SERVICE BULLETIN

M-1205

2007 SERVICE LITERATURE UPDATE

To communicate updates to 2007 model year service literature.

Figure 1. Fastener Torque Sequence

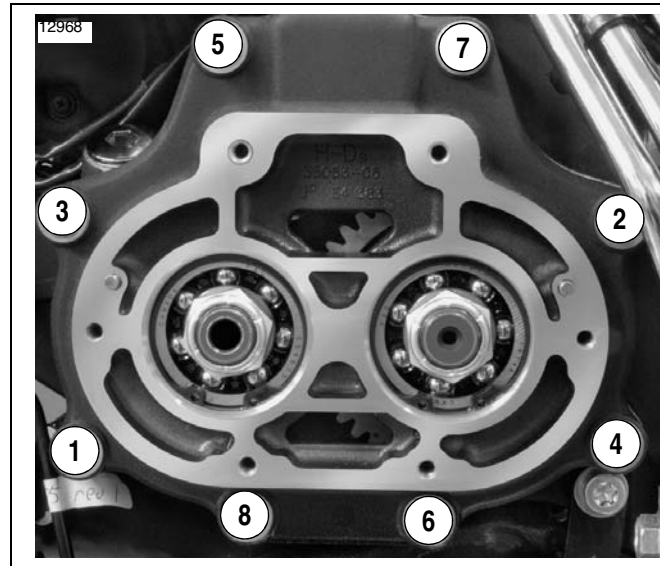
See Figure 1. Please note that the fastener torque sequence has revised for the above mentioned models and should be performed as shown. Refer to page 7-22 in service manual 99481-06 for 2006 Dyna, page 7-22 in service manual 99481-07 for 2007 Dyna, page 7-22 in service manual 99482-07 for Softail, and page 7-16 in service manual 99483-07 for Touring model motorcycles to update information.
